State of Washington
DEPARTMENT OF FISH AND WILDLIFE

SUBJECT: WDFW COMMENTS ON CU-15-00002 YAKIMA RIVER CAMPGROUND

SUBJECT: Yakima River Campground (CU-15-00002, SD-15-00001, SP-15-00001) shoreline/floodplain development located near the confluence of the Yakima and Teanaway Rivers

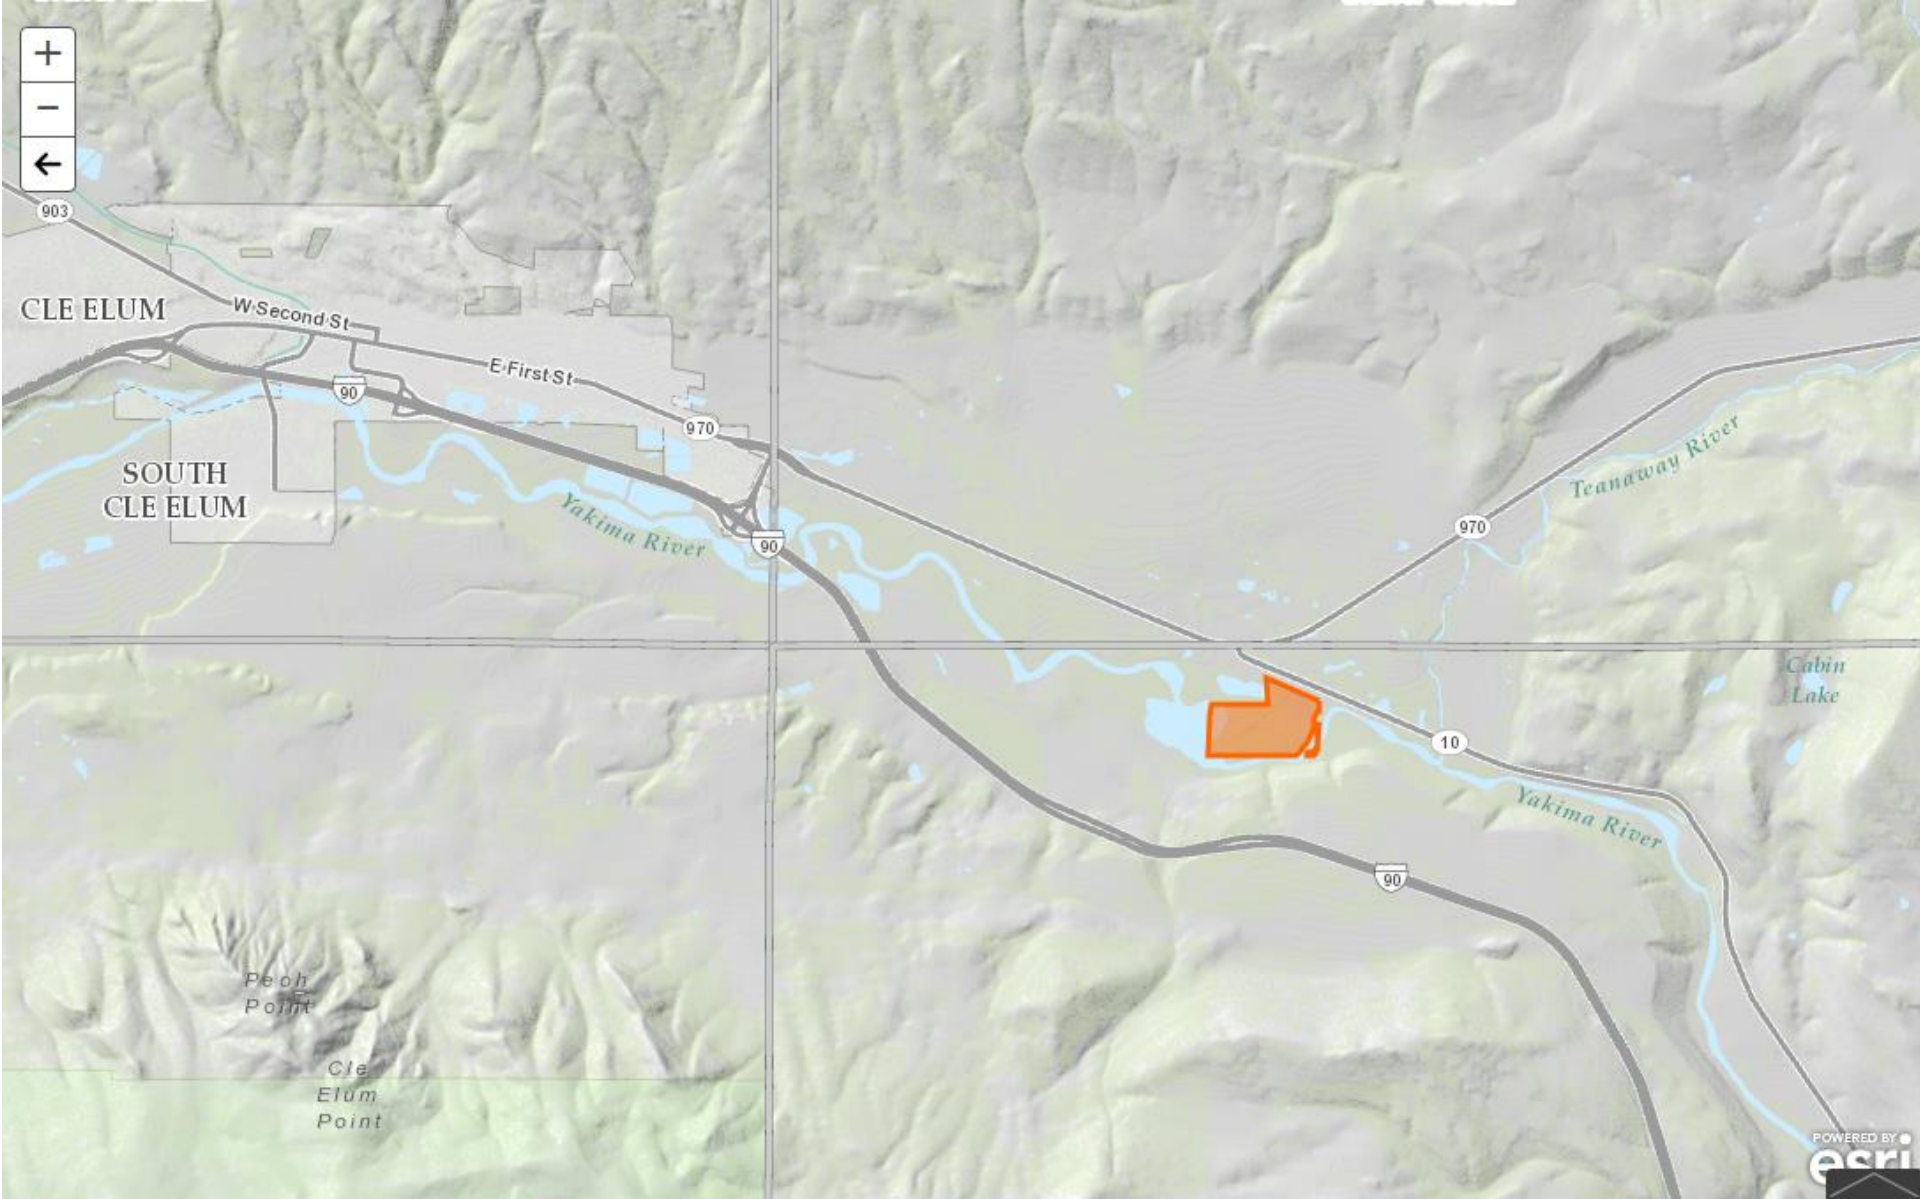
In June of this year, the property experienced overland flooding (Figure 1) from the Yakima River as did the private properties immediately to the west (upstream). High flows in the Yakima River activated a side channel, flooding WDFW's access road for the Teanaway Junction Water Access Site and the private properties east of WDFW's parcel, including the pond that was previously constructed within this side channel's flow path. A breach of the eastern pond edge resulted in flooding of the northwestern portion of the Yakima River Campground property where the RV sites are proposed. On June 6, 2022, Teanaway Ridge, LLC requested and received an emergency Hydraulic Project Approval (HPA) from WDFW to remove a culvert from the side channel/slough that was further backing up floodwaters on their property near the proposed RV locations. As of this date, WDFW has not received an application for an HPA to repair the breach of the pond and water is still flowing from this breach toward the Yakima River Campground RV sites (Figure 2). We present this as evidence of several critical areas present on this property including frequently flooded areas, wetlands, geologically hazardous areas, and Fish and Wildlife Habitat Conservation Areas and the need for an updated critical areas assessment and report. This also demonstrates the importance of protecting riparian and floodplain habitat within the channel migration zone (CMZ).

Figure 1. This photo was taken by Jennifer Nelson, WDFW, on June 6, 2022 from the edge of the pond immediately east of the Yakima River Campground property. This photo was taken from the adjacent property, looking at flooding toward the western portion of the Yakima River Campground property; near where the RV sites are proposed (electrical panel is visible between the trees, near center of photo).

As part of the online record available to review on the County's website, there is a May 6, 2022 letter from Jeremy Johnston, Planning Official, acknowledging changes to the Critical Areas Ordinance since the original comment period and requesting an updated critical areas report and a channel migration zone study. WDFW strongly supports this request and the need for additional information on all critical areas present and how the proposed project will prevent degradation of critical areas (KCC 17A.01.010(1)). The flooding experienced in June is further evidence that the CMZ study requested is a necessary element prior to the project moving forward.

Proposed Development for the Yakima River Campground

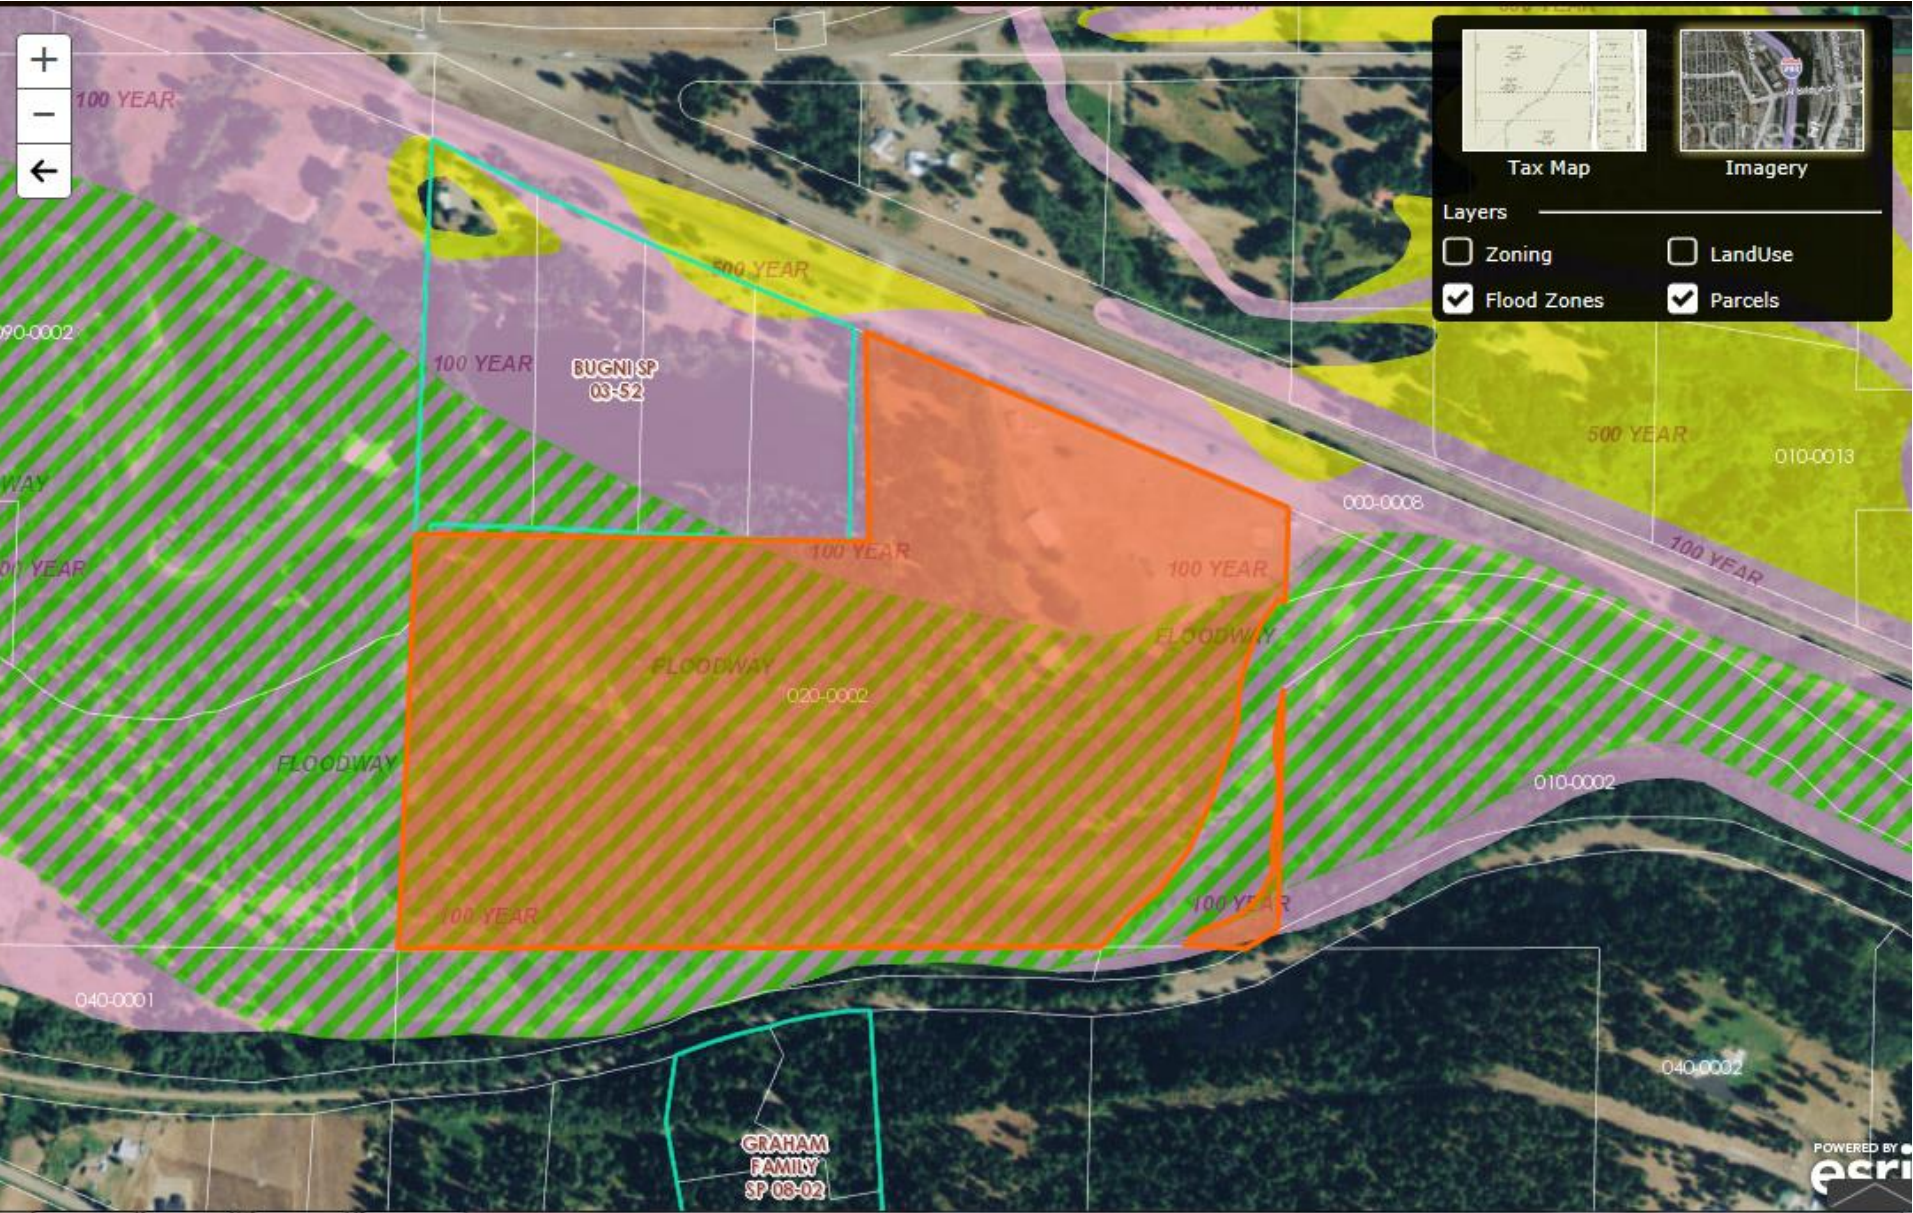
The map of the proposed development shows a road throughout the floodway leading to a boat ramp and parking area but this component of the project is not discussed anywhere else in the proposal. We recommend excluding this from the proposal or at the very least, minimizing the road construction through the floodway to the shortest route possible. As currently shown, the road and boat ramp would have substantial adverse impacts and should be eliminated from the proposal. The road identified does currently exist in a degraded and overgrown condition, with portions being eroded by the actively moving channels of the Yakima River. Although the road exists, we have no evidence of roads being approved in the floodway so the existing road is likely not authorized and should not be upgraded, used, or maintained.

The SEPA checklist appears to have some inconsistencies with the project narrative and map of proposed plans. It refers to roads outside of the 200 foot shoreline buffer and yet the map shows roads within this buffer. It also mentions that the floodway will be part of the designated open space, yet the map shows numerous camp sites within the floodway. It goes on to say that open space will allow for recreational trails, sitting areas, picnicking areas, viewpoints and ponds. It would be helpful to have more information on what the “open space” designation means, what will be allowed and encouraged, and where it will occur. The floodplain pond that is referenced above would not effectively increase flood storage. The primitive tent campsites are described as being natural (no pad construction), but plans show they will have roads, fire rings, a BBQ, and picnic tables.

- Please clarify exactly what is proposed within the floodway. The narrative states that no construction will occur for the seasonal primitive tent sites but on the very next page it states that each of the 69 units will be 61' long and 32' wide. The map indicates that parking spaces, picnic tables, fire rings and BBQs will be provided at each site in addition to the roads required to access these campsites.

The LIDAR image with the proposed Yakima River Campground parcel highlighted in orange. The flow paths and recent channel scars are evident throughout most of the property.

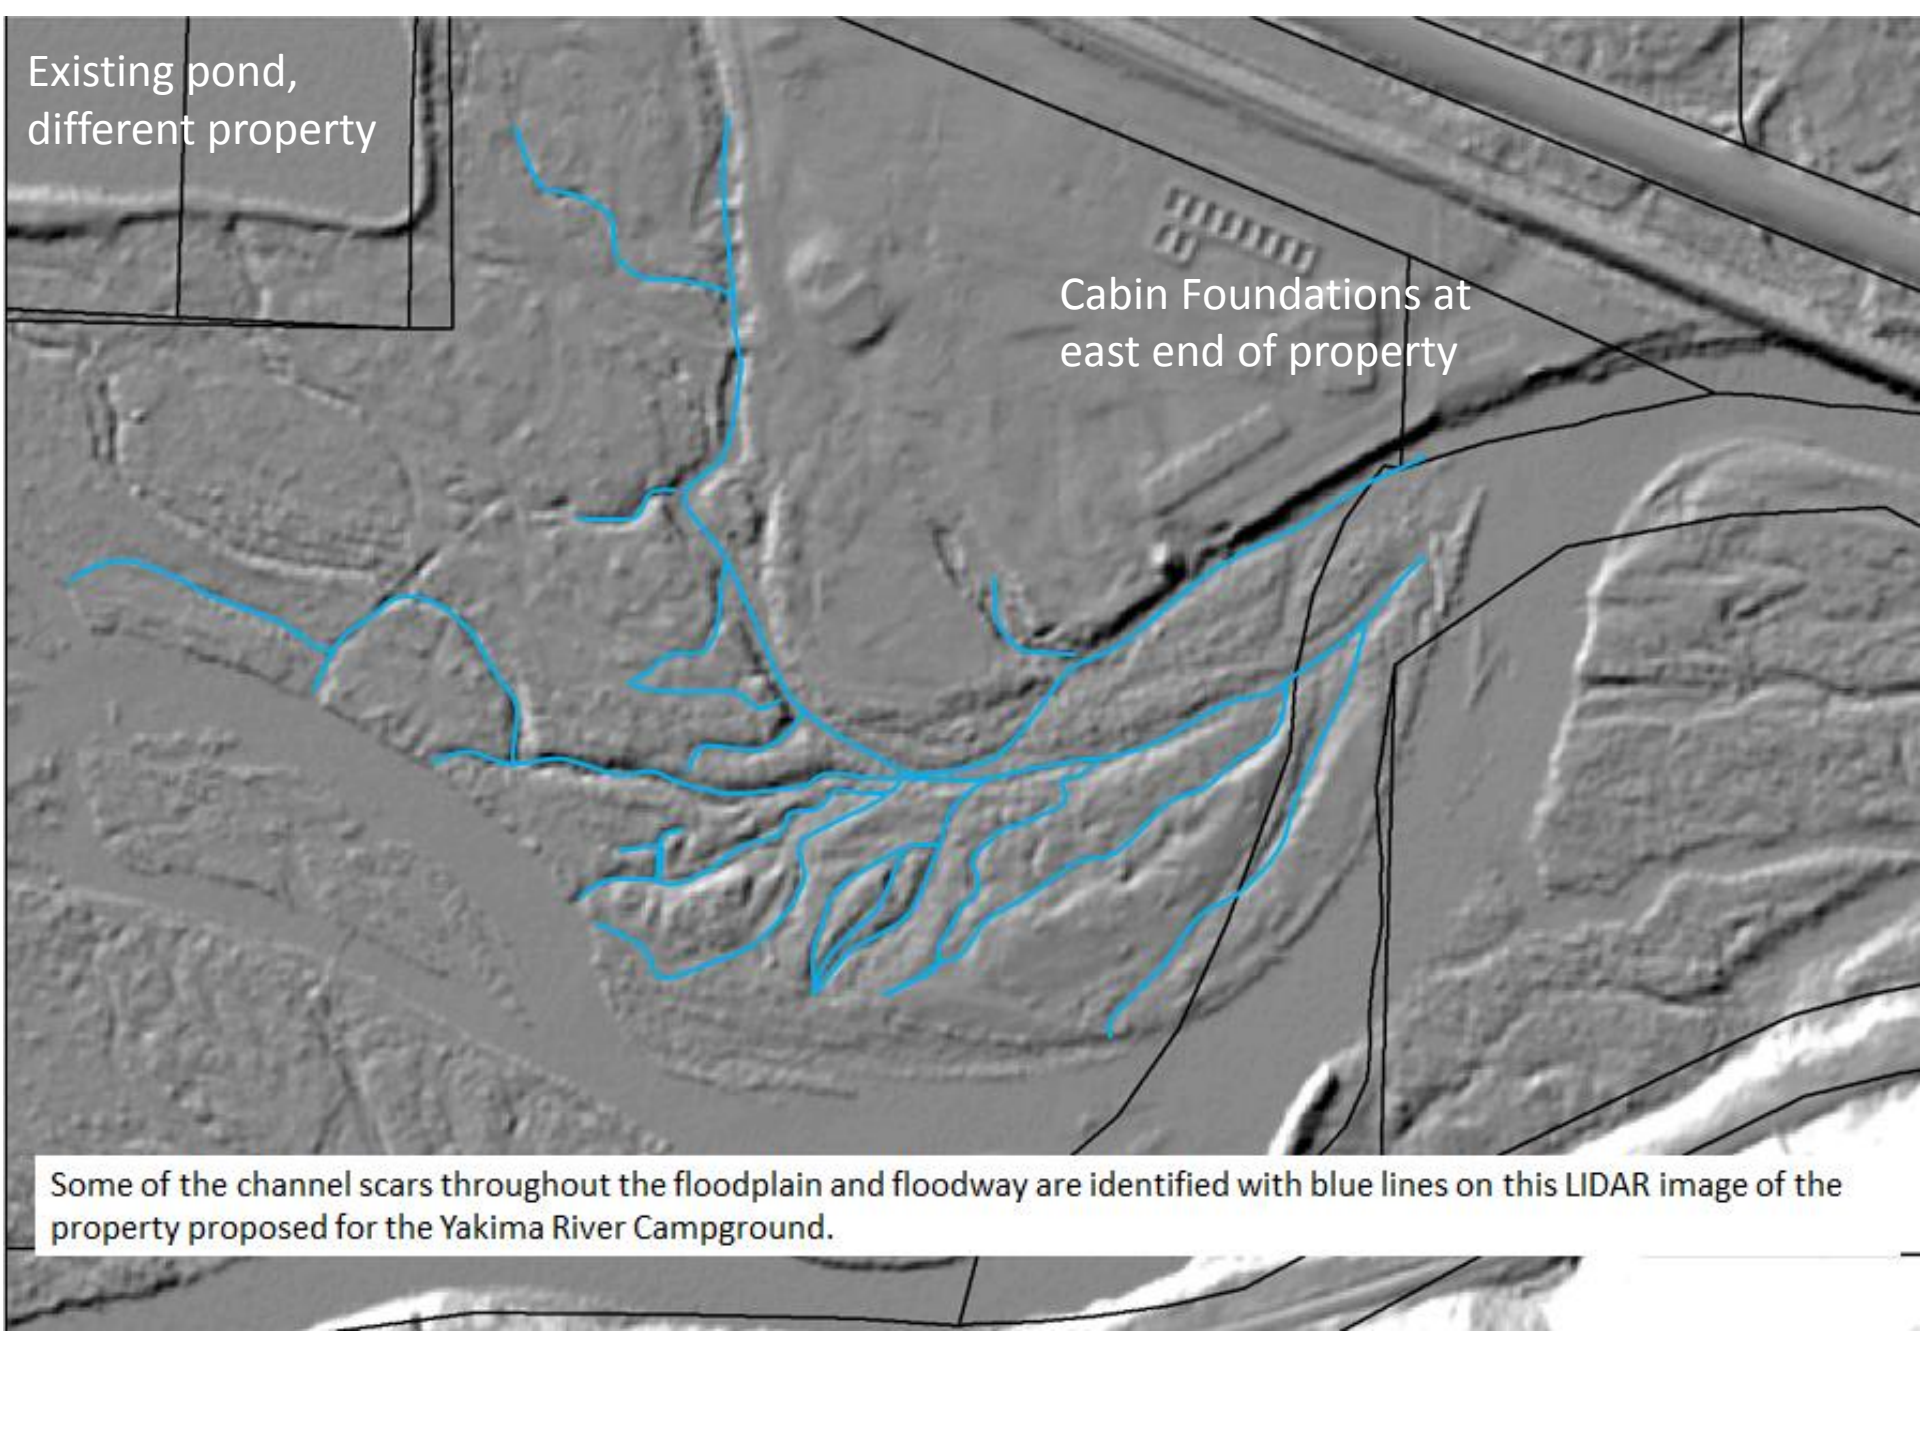
Some of the channel scars throughout the floodplain and floodway are identified with blue lines on this LIDAR image of the property proposed for the Yakima River Campground.

We encourage the applicant to focus their development on the most stable, high ground with the least risk of flooding, erosion, or avulsion. Based on the LIDAR image, this is the area where all of the existing buildings are located and approved. If campsites are to be located in the floodway, they should be walk in only and a much lower density than is currently proposed. Campsite location and density needs to address the need for preserving shoreline vegetation (which is critical for shoreline stability). Occupancy of the campsites should be limited to certain times of the year when risks of flood are low as nearly all tent sites and RV sites are located west of the stream and will need to use the single small bridge to safely exit the campground. An alternate exit west of the current driveway may be worth considering.

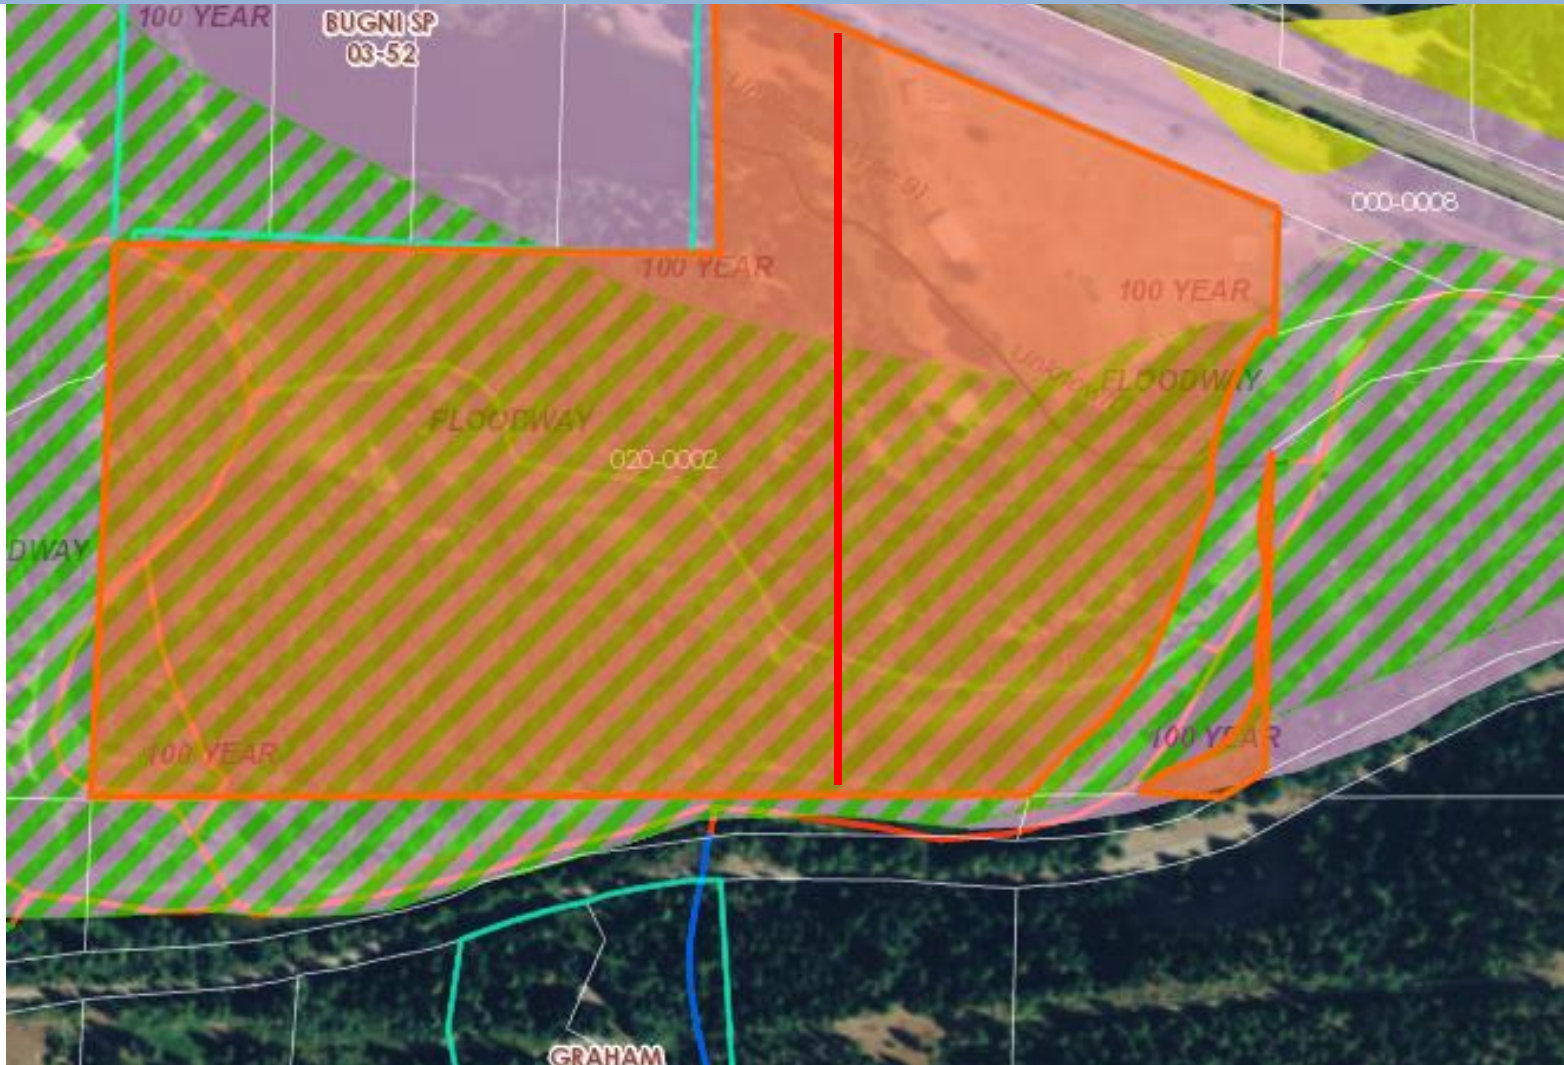
Currently Proposed Short Plat with floodway, floodplain and streams identified. The Unknown/Type 9 stream through the northern portion of the proposed parcels appears to follow the old side channel path present in the 1954 aerial photo. With construction of the adjacent pond, the channel no longer flows in this alignment and is actually more north/south oriented. Nonetheless, development opportunities on the western lot would be limited by CMZs and other critical areas.

The proposed short plat to divide the property into 2 parcels is of concern to WDFW. The existing wetlands, side channels, CMZ, and floodway make development within this area quite challenging. The proposed short plat divides the property into parcels that will likely require variances and exceptional treatment for development by future landowners. If the short plat is simply a tool to vest the applicant's proposal in the outdated 1975 Shoreline Master Program, rather than the updated 2016 SMP, it seems to defeat the intent and purpose of the Growth Management Act and the Shoreline Management Act.

If necessary, we suggest drawing the short plat lines differently such that the slight terrace where the existing buildings are with minimal vegetation is one parcel and the remaining lower elevation forested and floodplain is the second parcel; it could be placed in a conservation easement to protect it development in perpetuity while providing a tax incentive to the owner. A draft concept of this is provided in the enclosure.
